TECHNICAL NOTE

from:	[REDACTED]	date:	16/2/2022
subject:	3/2020/0911. Shackletons Garden Centre Ltd Clitheroe Road Chatburn BB7 4JY, Proposed two-storey extension Including additional indoor and outdoor retail space and increased cafe area and play area.	file ref:	J1168-TN1

This Technical Note sets out the response to the feedback.

servicing/staff entrance - articulated delivery vehicle tracking

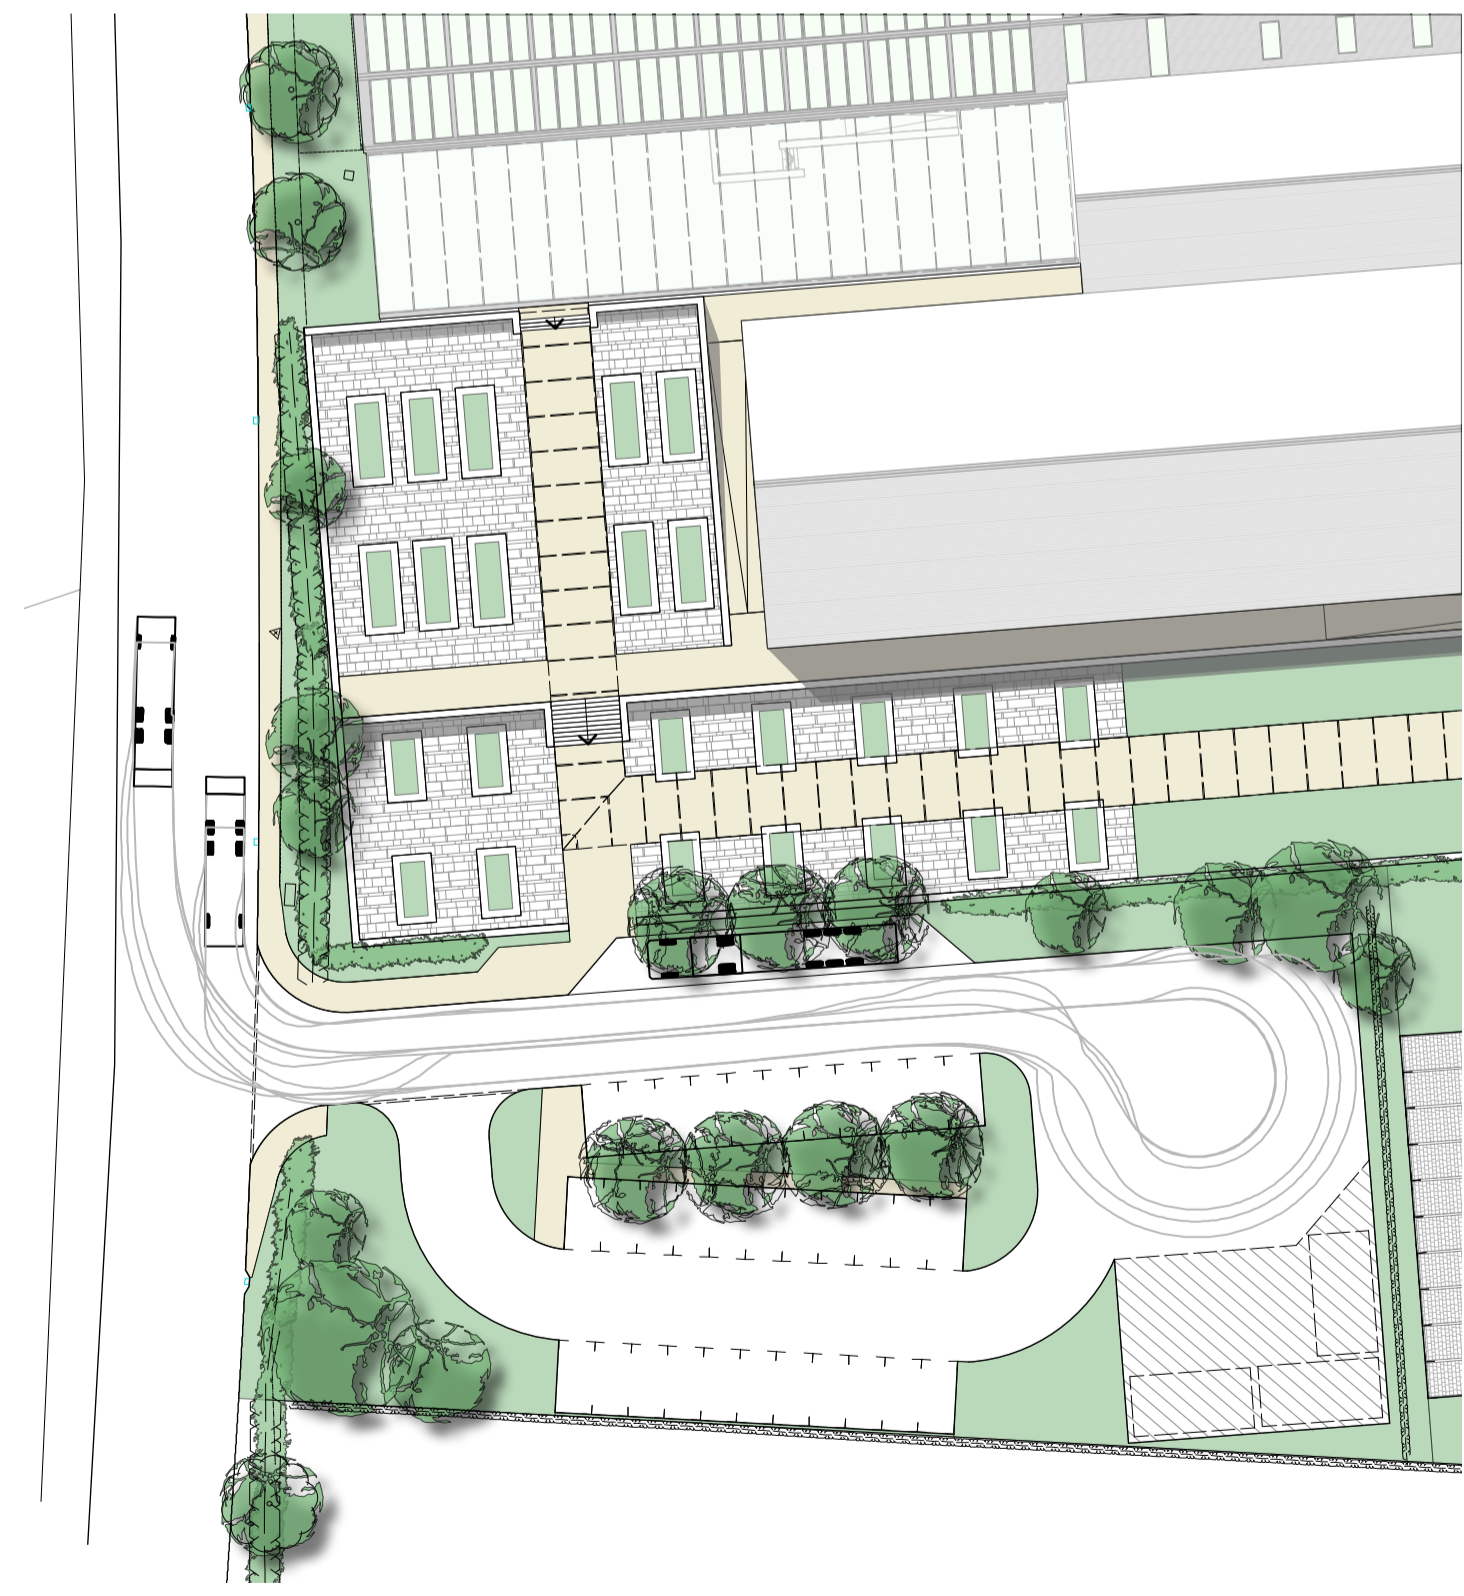
While the LHA have reviewed the drawing and the access arrangements along with the visibility splays comply with the LHAs guidance, the LHA are concerned about large delivery vehicles using the access. This is because as shown on the swept path analysis drawing on the revised plan, the delivery vehicle exiting the site and turning right onto Worston Road, overlaps the grass verge and then the footway as it exits the site.

The drawing also shows its extremely narrow for delivery vehicles to enter the site, with the swept path being extremely close to the footway. Therefore, the LHA require the access and the carriageway into the site to be widened which should be shown on a revised drawing. A revised swept path analysis drawing should also be submitted.

The paths have been updated to show the turn can take place with no overlaps, it should be noted that the green lines indicate the edge of the vehicle body and the redlines the track of the wheels.
